IN THE DRAWINGS:

REMARKS:

Serial No. 10/789,134

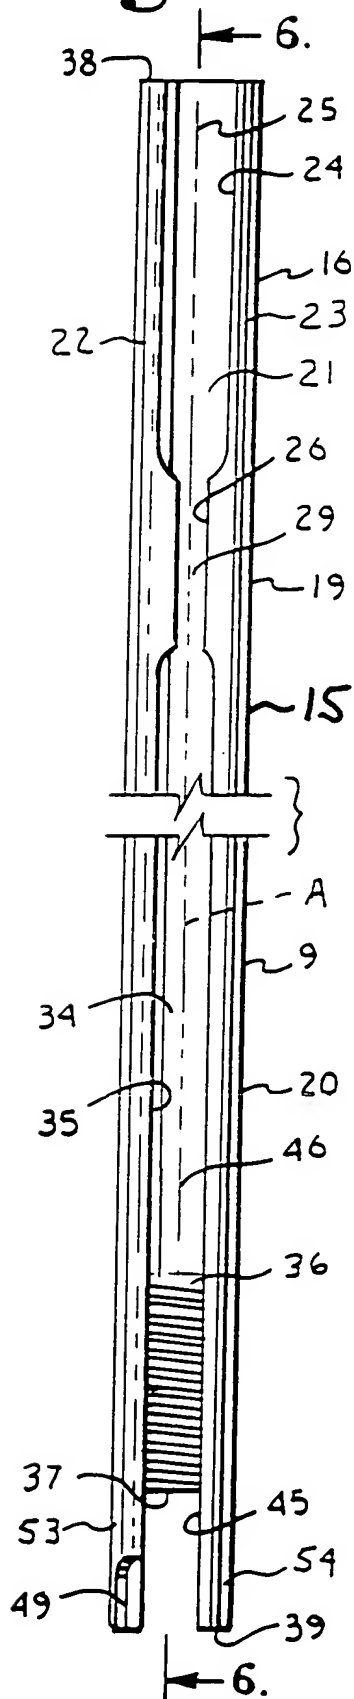
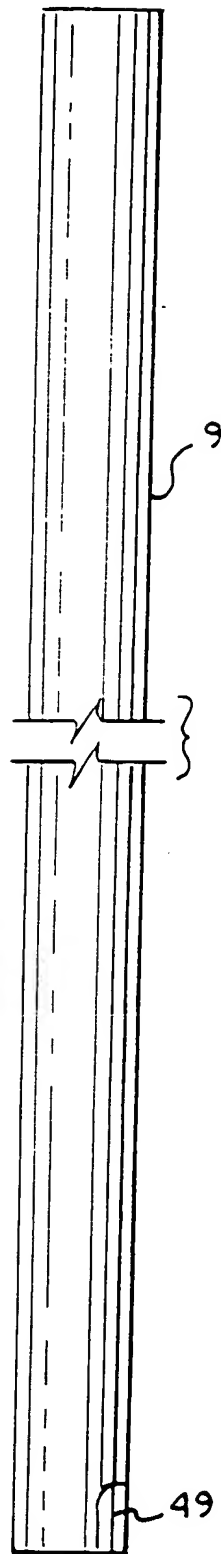
An objection was entered with respect to the specification in that the reference numeral 14 was twice used. This has been corrected and a new sheet of drawings of Figs. 4, 5 and 6 with this numeral is included along with a copy of the original drawings marked in red to show the proposed change. Kindly substitute the enclosed drawings for the original drawing. Certain other changes have also been entered to correct typographical errors found in the application. None of the changes to the specification or drawings submits any new matter.

Please substitute the new sheet of drawings showing Figs. 4, 5 and 6 for the original sheet showing the same Figures.
